LAND USE APPLICATION COMPLETENESS REVIEW

Second Review Comments

Subject Property: 1105 Front Street NE

Reference Nos.: 24-106451-PLN (Class 3 Site Plan Review, Tentative Subdivision Plan, Class 1 & 2 Adjustment, Class 2 Driveway Approach Permit)

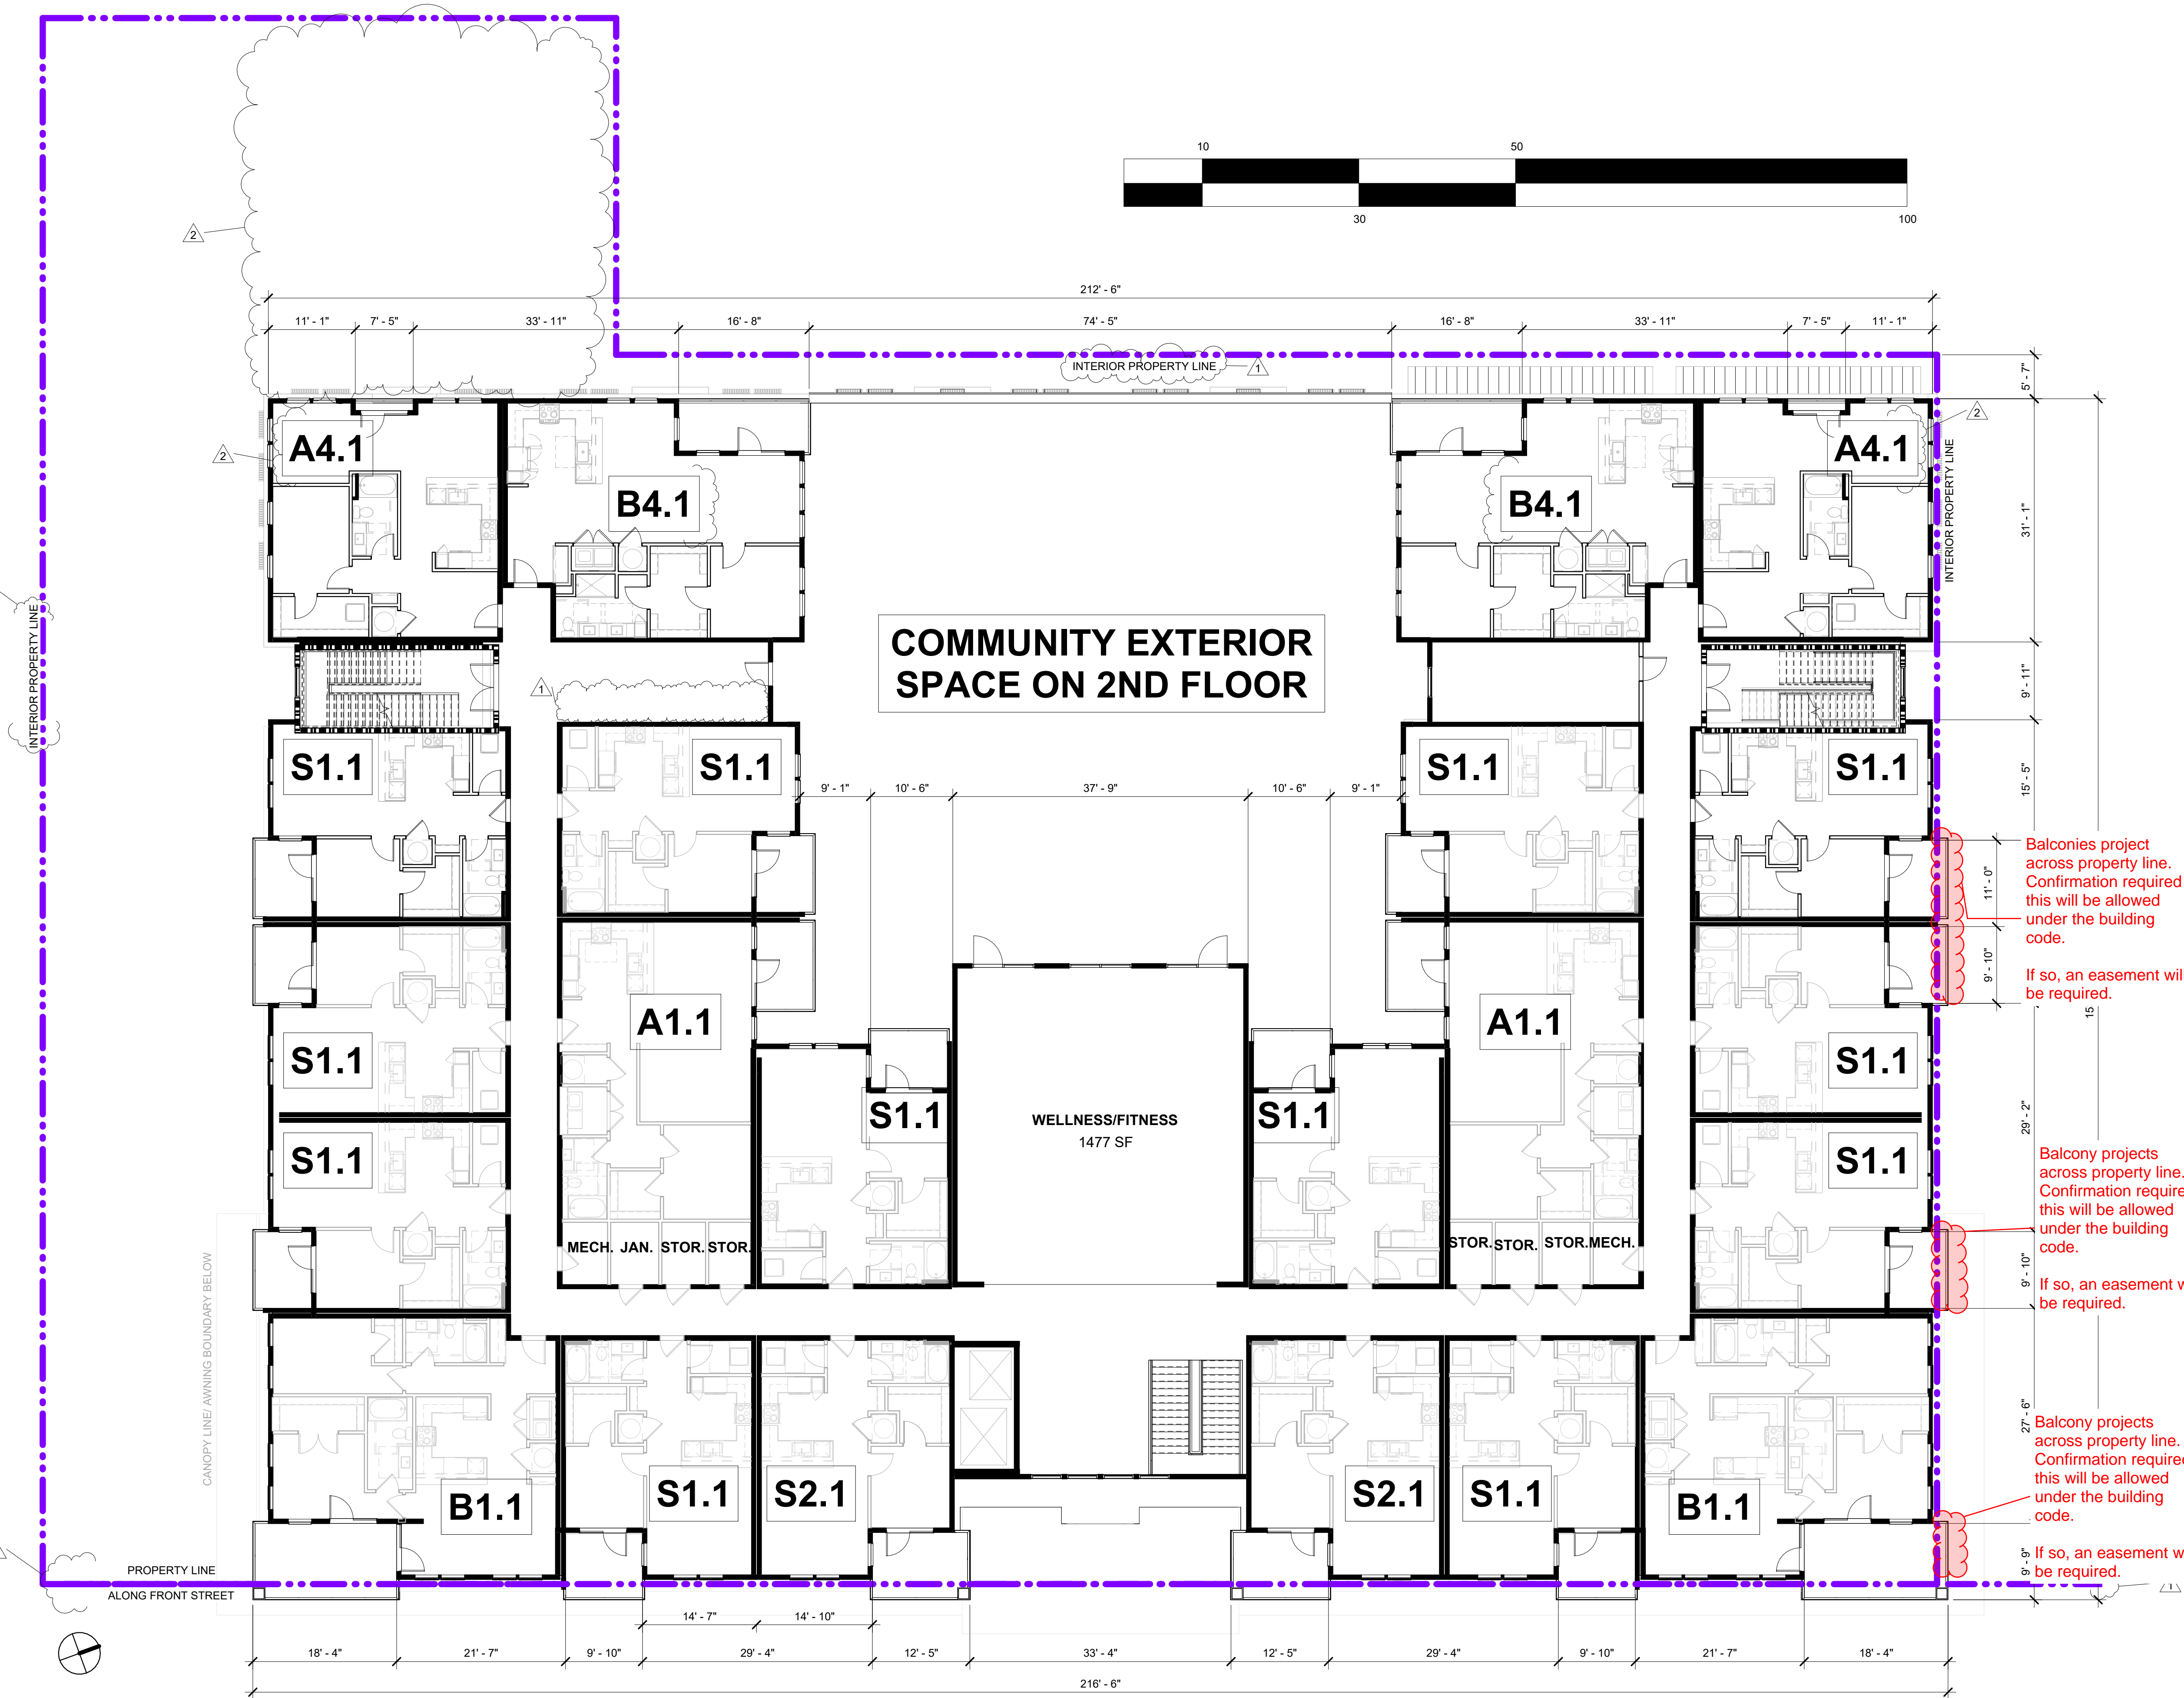
It appears that portions of the building project over the property line. Confirmation required if this will be allowed under the building code.

If so, an easement will be required.

Canopy projects across property line. Confirmation required if this will be allowed under the building code.

If so, an easement will be required.

Canopy projects across property line. Confirmation required if this will be allowed under the building code.

If so, an easement will be required.

Min. 8.5-foot compact stall width required when the parking space abuts a wall or post

Min. 8.5-foot compact stall width required when the parking space abuts a wall or post

Min. 8.5-foot compact stall width required when the parking space abuts a wall or post

Each staple bike rack accommodates two bike parking spaces (one bike on each side of the rack). As such, these racks need to be removed.

Each staple bike rack accommodates two bike parking spaces (one bike on each side of the rack). As such, these racks need to be removed.

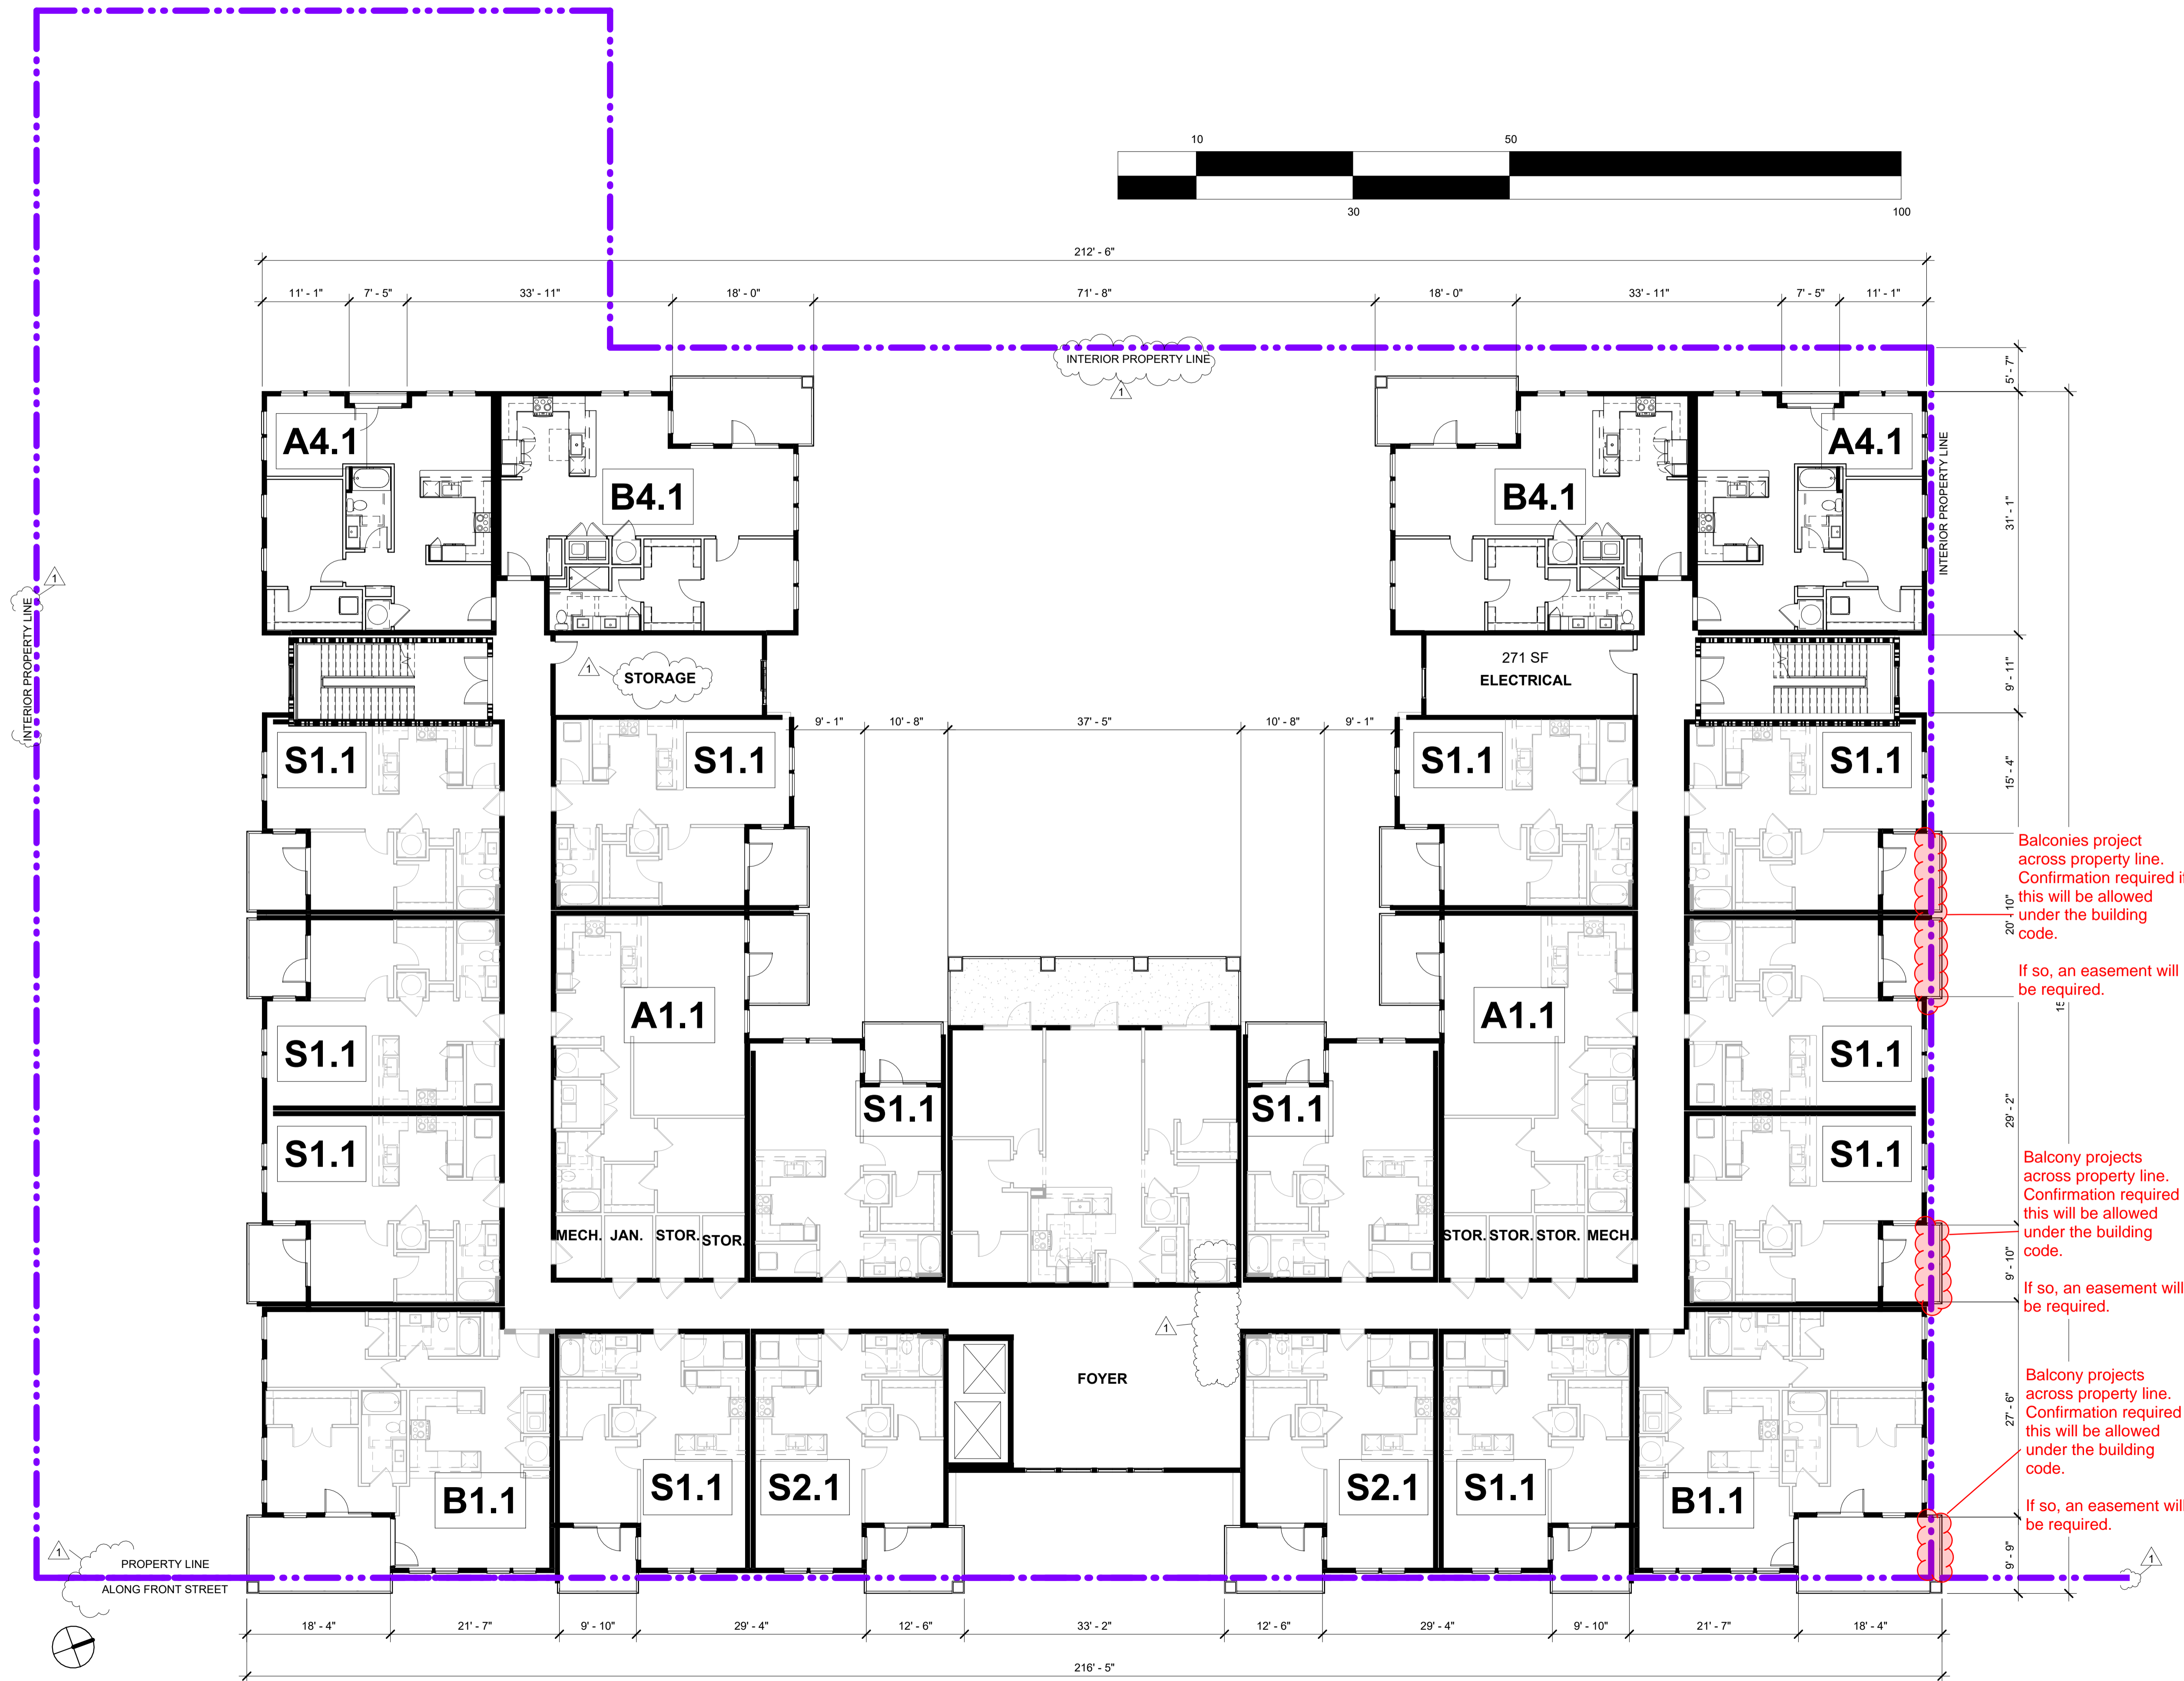
Balconies project across property line. Confirmation required if this will be allowed under the building code.

If so, an easement will be required.

Balcony projects across property line. Confirmation required if this will be allowed under the building code.

If so, an easement will be required.

Balcony projects across property line. Confirmation required if this will be allowed under the building code.

If so, an easement will be required.

Balconies project across property line. Confirmation required if this will be allowed under the building code.

If so, an easement will be required.

Balcony projects across property line. Confirmation required if this will be allowed under the building code.

If so, an easement will be required.

Balcony projects across property line. Confirmation required if this will be allowed under the building code.

If so, an easement will be required.
